**Comments on the validation of  
Gudur Thermal Power Project, India  
28 April 2011**

CDM Watch respectfully submits the following comment on the Project Design Document (PDD) for “Gudur Thermal Power Project”, India. We highlight the importance of recognizing the integral role of transparency in the CDM validation process, and for taking this comment into consideration.

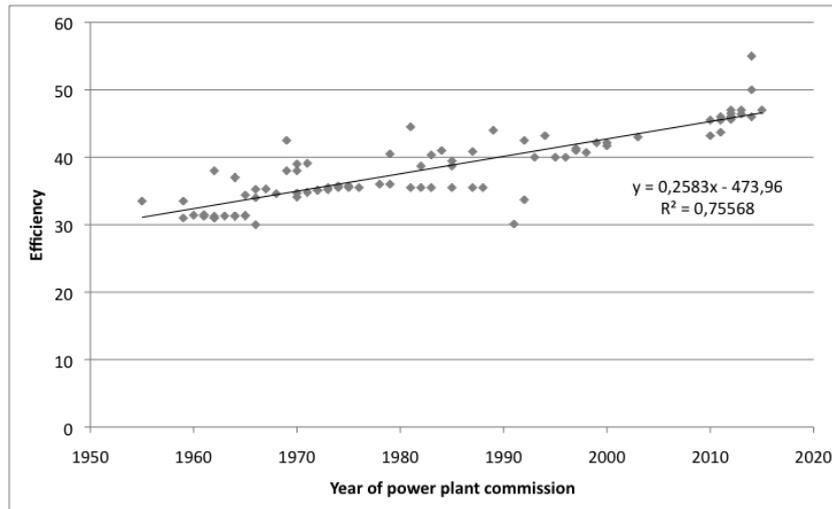
- The figure below from IEA (2008b, page 51) illustrates the efficiency improvements achieved in coal fired power plants in China. The figure shows that power plants between 100 and 400 MW, constructed in the last 10 years are 5-6% more efficient than power plants constructed in the ten years previously. This results in efficiency gains of 0.5% to 0.6% per year for power plants built in the most recent decade. The figure also shows that the improvements vary with the size of power plants and over time.

***Against the above said, project developers must show how the project takes into account the baseline efficiency improvement.***
